Access Compliance Report

Public Rights-of-Way

(Curb Ramps)

Intersection ID: 51667	Main Street: HUCKS_RD	Cross Street: SWEETBRIAR_RIDGE_DR	Location: NE
ADA ID: 7E7DEE9130AE	Ramp Type: BlendTrans2	Initial Pass/Fail: Pass	Overall Compliance: No
Severity Score: 0			
Codes/Mitigation Info/Possible Solution		Field Measurements/Component Compliance

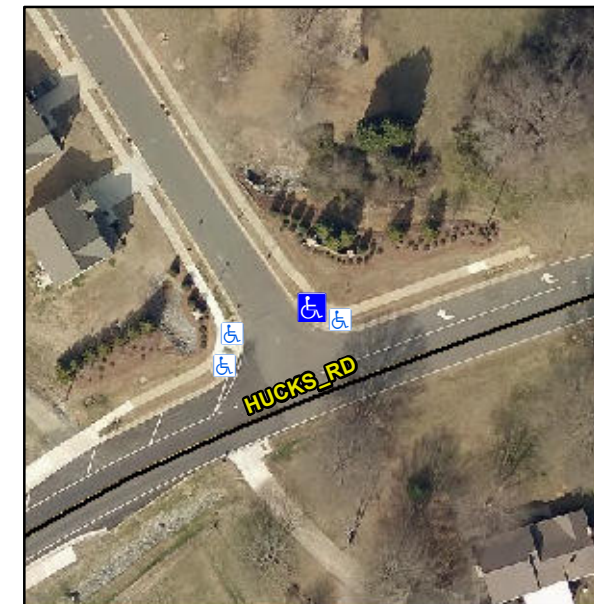
PONDING IN RAMP

Not Found, R305.2, R302.7

Remove & Replace Curb Ramp With Two New Directional Ramps or Equivalent.
